RE: Shearer Cottage expansion

Subject: Shearer Cottage expansion

I hope all is well. We are reviewing the Shearer Cottage expansion plan, which involves these 3 properties:

4 Morgan and 7 and 8 Highland Highlands Plan Marked Up Final.png; 102408 Shearer Site.pdf;

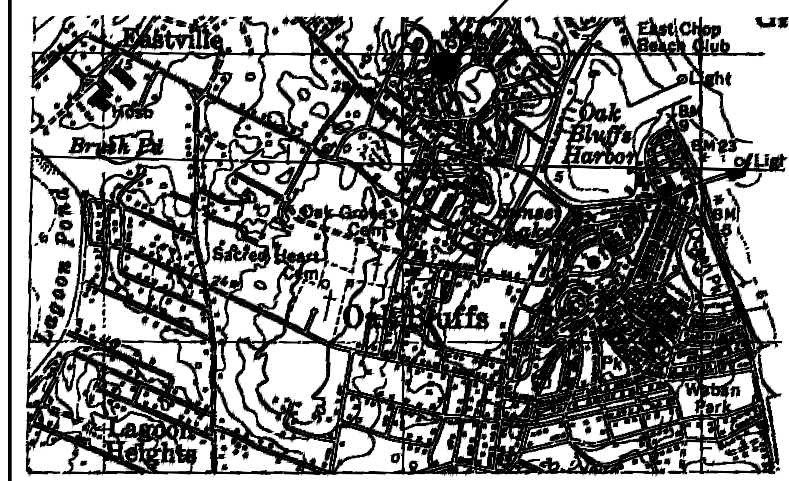
Good morning Alex. After reading the deed (and a few previous deeds) for 7 Highland I agree with the applicant that this has been incorrectly mapped for assessing purposes. I recently submitted my FY22 mapping to our consultant and expect 3-119 to be enlarged to show this.

I also believe 4 Morgan will be extended further north. I've attached a very rough sketch of how it should look.

I do notice that their plan is slightly different from our expected mapping on where the top of both parcels nearly meet. On theirs, 4 Morgan goes just past 7 Highland while on the mapping I've done it is the opposite.

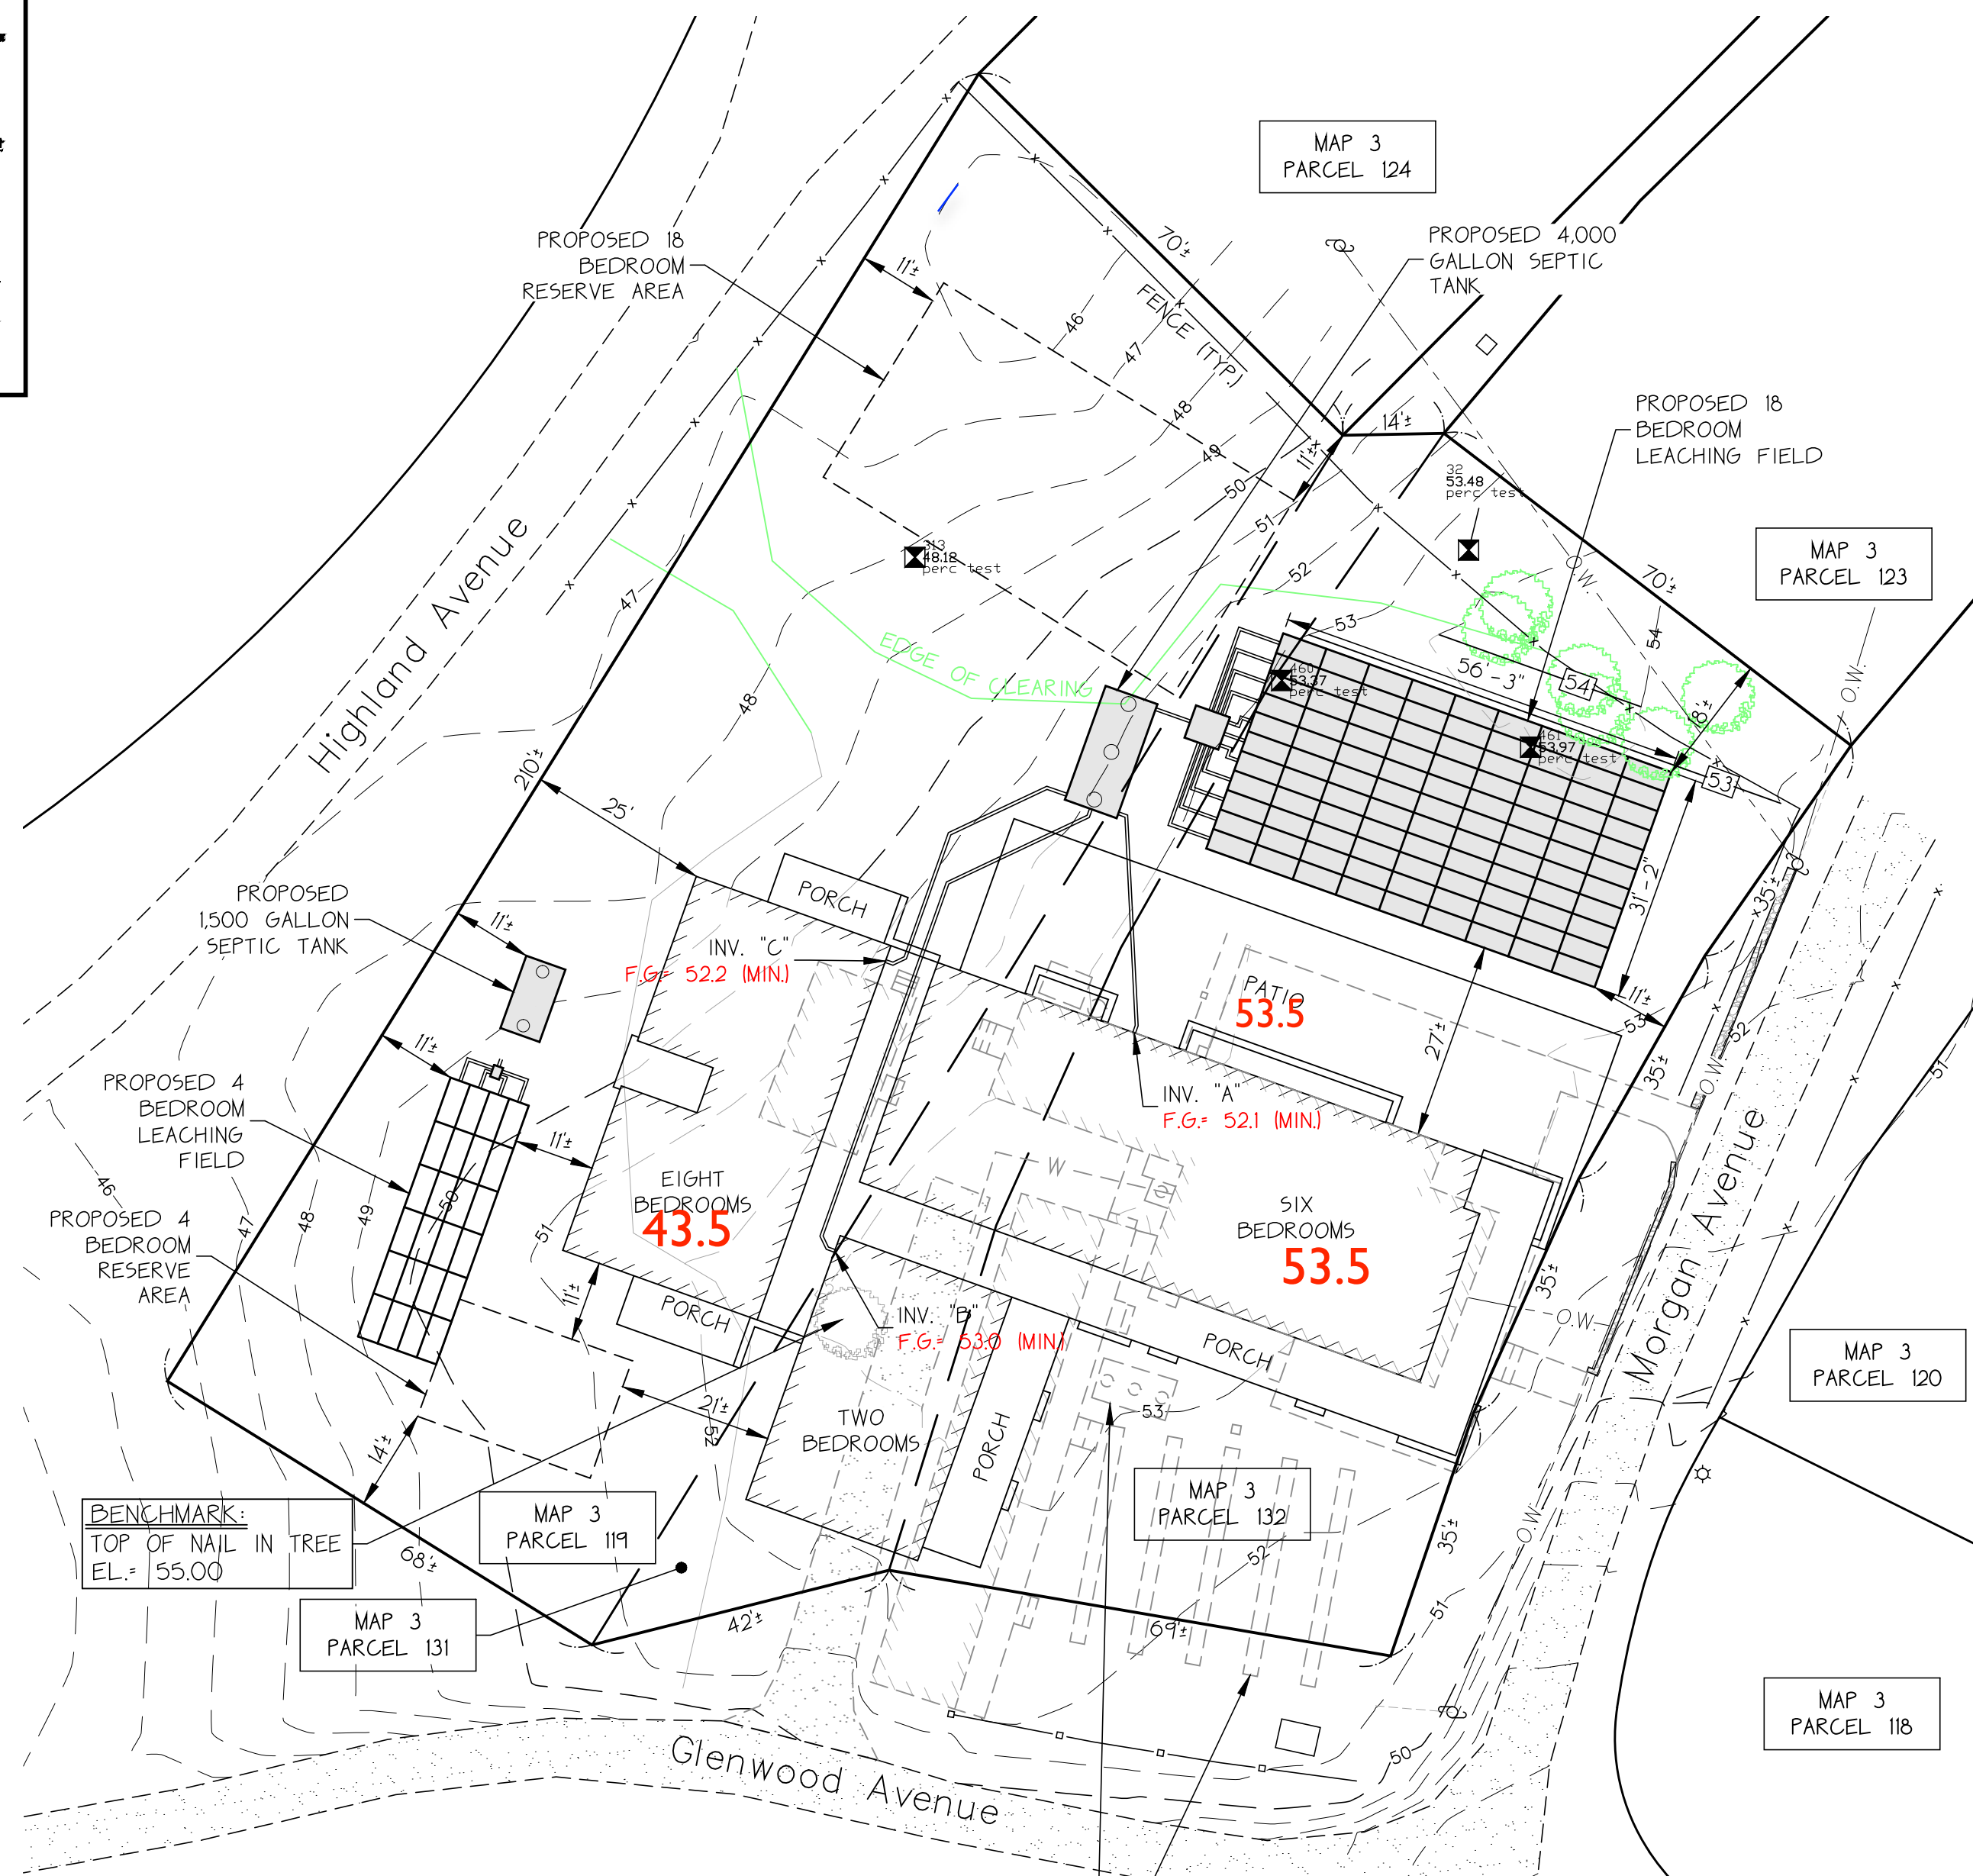
I won't have square footage until the mapping is complete. Chris Seidel might be able to help with that if it were urgent. But I'd expect the applicant could supply that information? I've attached a plan I was sent that shows the combined parcel outlines (I am not combining 7 Highland and 4 Morgan myself).
